PROJECT REVIEW

1. CASE 23.028, 107 BENEVOLENT STREET, Amasa Sprague Stable, c 1850 (POWER-COOKE)

PHDC Staff Report October 23, 2023

107 Benevolent PHDC sub-committee notes

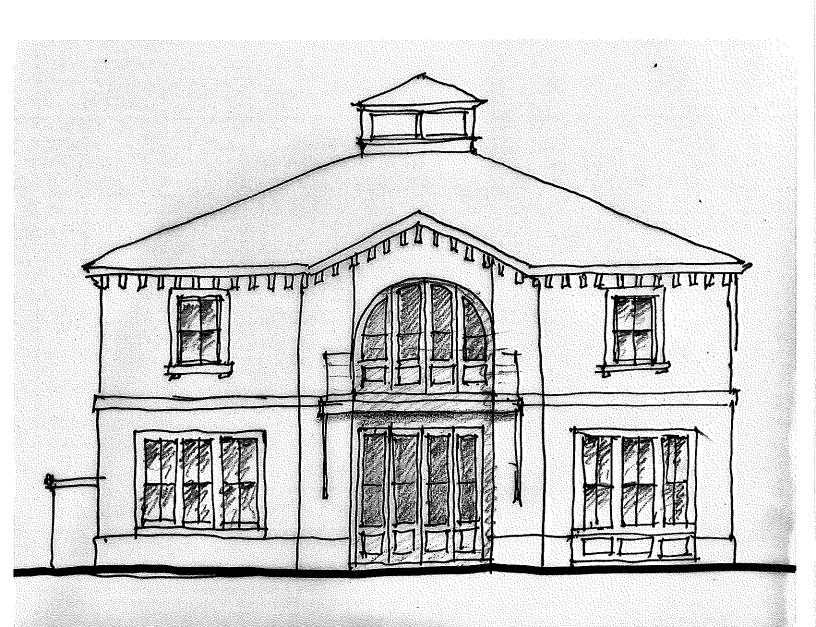
2. On the south elevation, it is extremely regrettable that the arch was removed by saw cutting it and leaving irregular saw marks to create a vertical opening up to the underside of the gabled cornice. It does not look good. The original plan was to salvage the bricks of the arch and rebuild the brick arch as high as the arched opening on the north side (about 2' or 3'). That apparently was not feasible (and not conveyed to the PHDC until after the damage was done). Believe they are now being asked to agree to an infill design that's already framed in but is less than appropriate and out of sync with the history and character of the carriage house.

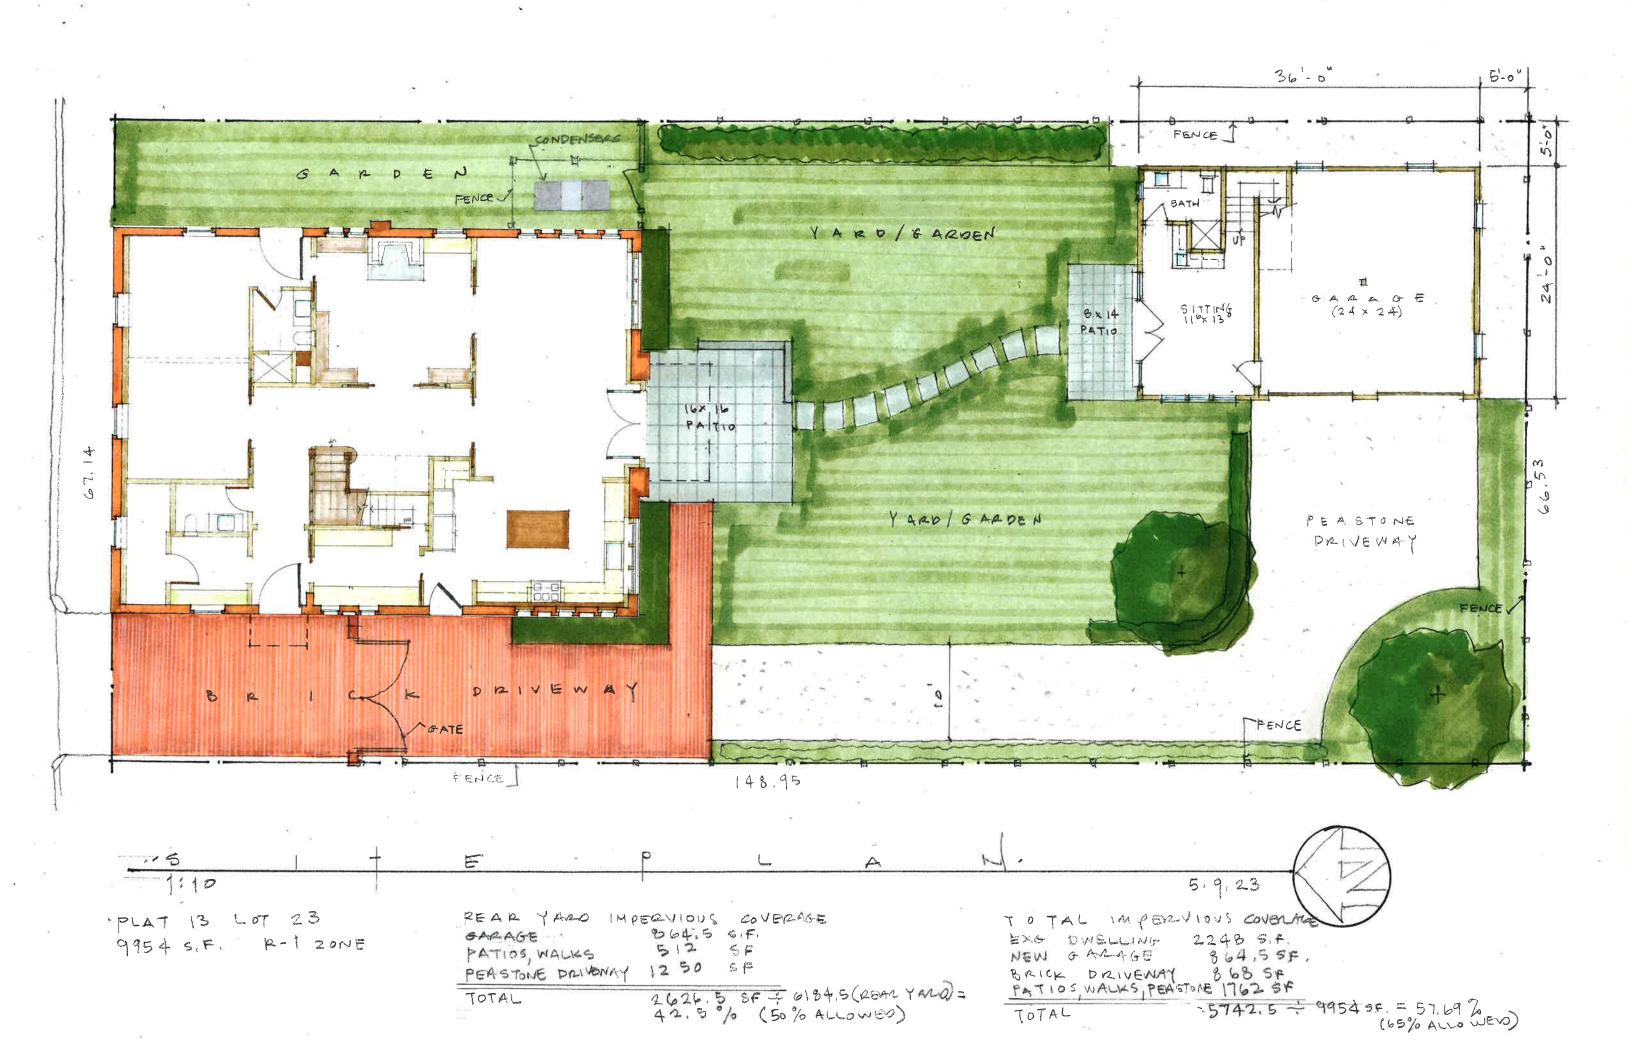
To recapture the original intent of the 3/8 proposal (which was approved), SC suggests a compromise of sorts depicted in a quick sketch, attached. The window and door treatment for the first and second floor arched opening should be in alignment and consist of French doors in the middle. The horizontal muntins could be optional. The blank panel between the arch top and the gable cornice could be flush with the brick walls on either side and painted a brick color. Or the panel could be recessed 4" say, provided the brick returns are properly rebuilt. (SC should also review the balcony detailing, which was not discussed.)

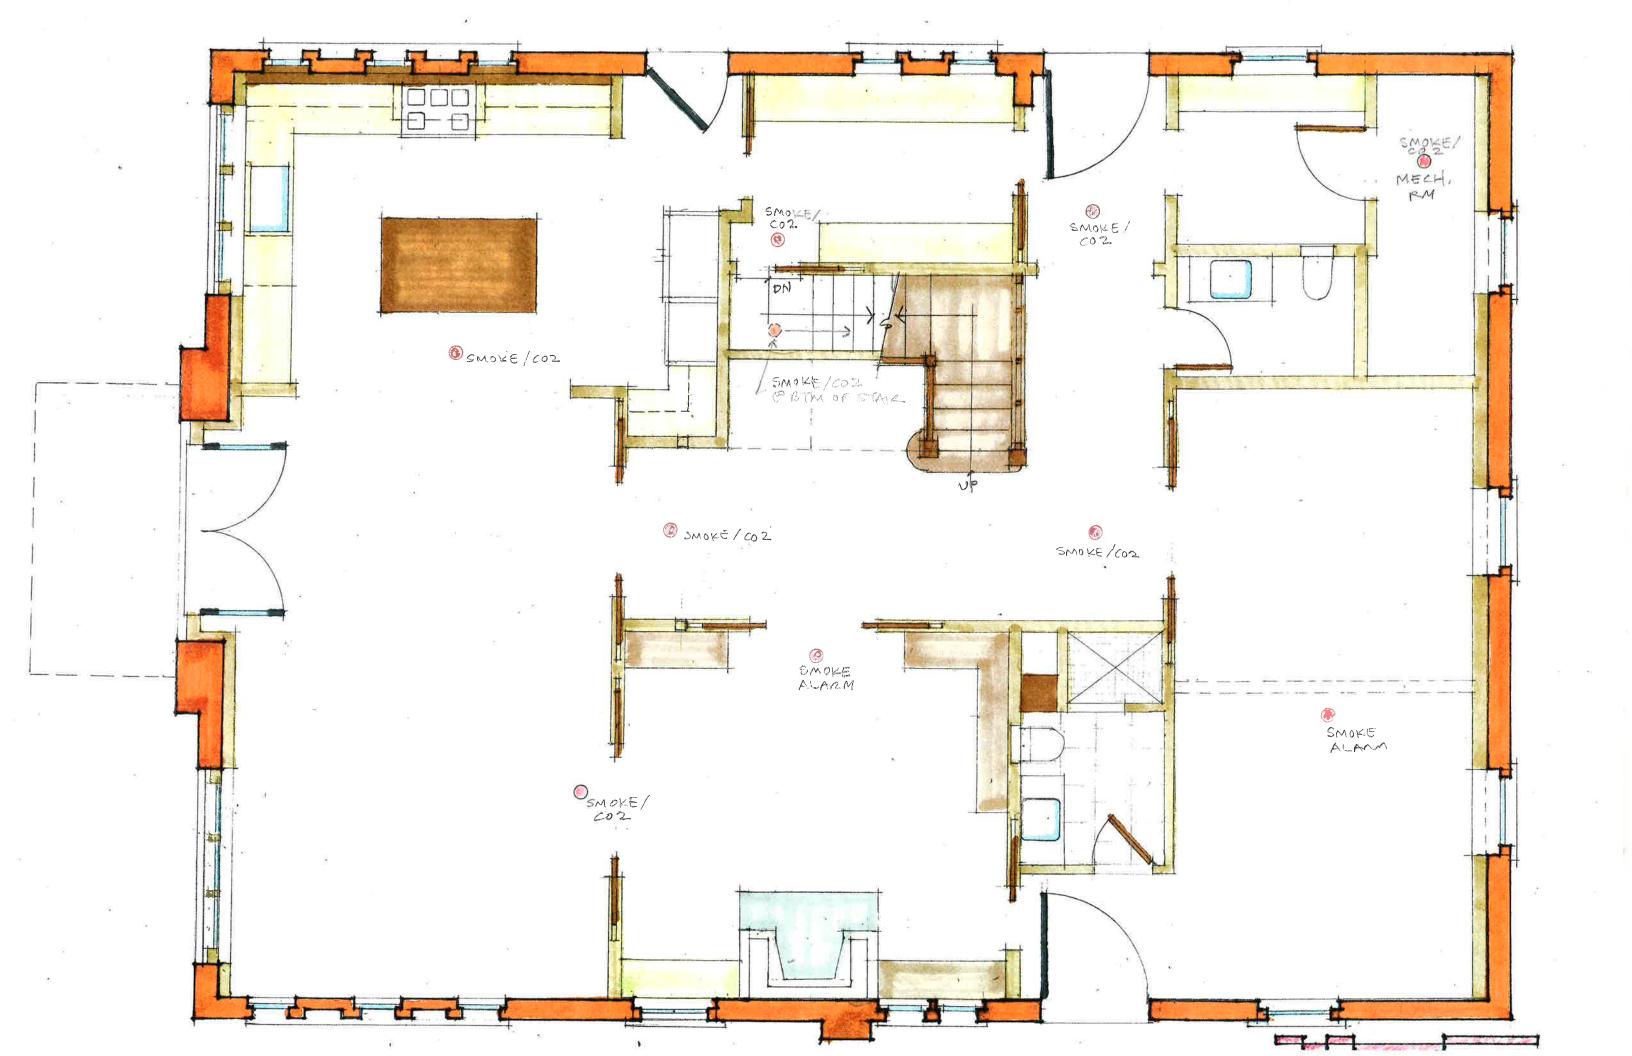
- 3. The large masonry openings on the south elevation on the first floor flanking the center doors also are concerning, especially given the way the wood framing for the windows has been installed. It suggests that the side and top casings will not be equal, as they should be and as depicted in the renderings. As the sketch shows, suggest that both sets of triple windows be the same dimensionally, with the windows on the left sitting on top of the existing stone foundation and no panels, if possible.
- 4. It is our understanding that the wing wall capped with stone that once anchored a gate will be reconstructed.
- 5. Although it is not within our purview, I suggest that Frank seek out the advice of Clark to provide a better color scheme for the trim.

REVISED NORTH ELEV.

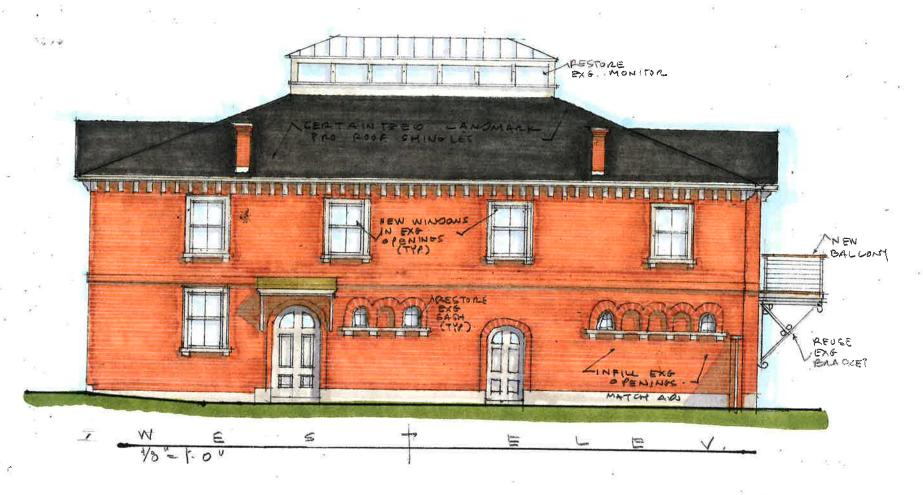
- There is also a request to change from the approved plan and introduce two windows to the front elevation, first floor, middle bay as proposed to the approved one window. The sub-committee did not think that this was an appropriate modification, staff concurs;

1. On the street (or north) elevation, the sub-com (SC) stated that the single window in the middle, simulating the flanking windows on the first floor, should remain as shown in the approved submittal.

According to Frank, the arched opening above will be infilled with remnants of the windows that were in the original arched opening on the south side (which is shown in the updated drawings). This is laudable but they prefer the original proposal shown on the 3/8/23 drawing. It has a lower sill and picks up on the scale and detailing of the other windows.

- It is staff's recommendation that the front elevation as originally approved should be retained and would recommend that the Commission request that the applicant amend the application and withdraw that portion of the supplemental application, while approving the supplemental revisions for the rear elevation. If the applicant requests a vote on the full supplemental documentation staff recommends bifurcating the approval and approving the rear modifications, while denying the front modifications; and,
